Re: Terilynne Terrace Drainage Report

Re: Drainage Report for Terilynne Subdivision

**DRAINAGE
REPORT
for the
TERILYNNE
SUBDIVISION**

POND CONFIGURATION DETAIL

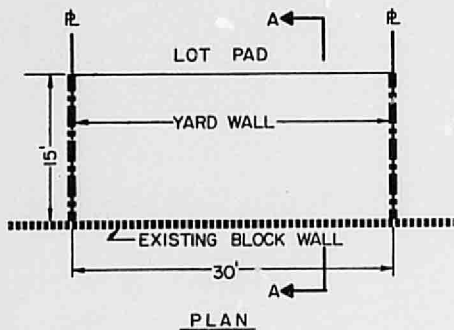
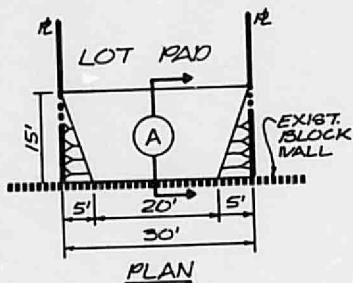
The grading plan also indicates that the runoff from the roof will accumulate against the garden wall to the south. What provisions will be made to prevent damages to the foundation and to the wall? The drainage report shows a detail of how the back yard ponding is supposed to be constructed. The same detail should be shown on the grading plan. I note also the ponding volume for the back yard ponds is computed using the procedure that makes allowance for the undeveloped runoff to exit the property. Since there is no way for the excess water to leave the property, the volume of the ponds must be adequate to handle 100% of the roof runoff.

It is my recommendation that a gravel trench be constructed in the ponding areas to supply the additional volume required and to remove from the back yards the runoff from the more frequent storms.

With rear yards as some as these, water has to be ponded against the walls and foundations. Therefore, a note has been added to our drawings requiring the walls and foundations to be water proofed. Pond volumes have been increased to exceed a 100 percent retention.

$$\text{Volume Required per Lot} = (30) (84) (0.2) = 504 \text{ cu. ft.}$$

$$\text{Average Pond Area} = 15 \times 30 = 450 \text{ sq. ft.}$$

$$\text{Average Depth of Pond} = 1.15 \text{ ft.}$$

$$\text{Pond Volume per Lot} = 517.5 \text{ cu. ft.}$$
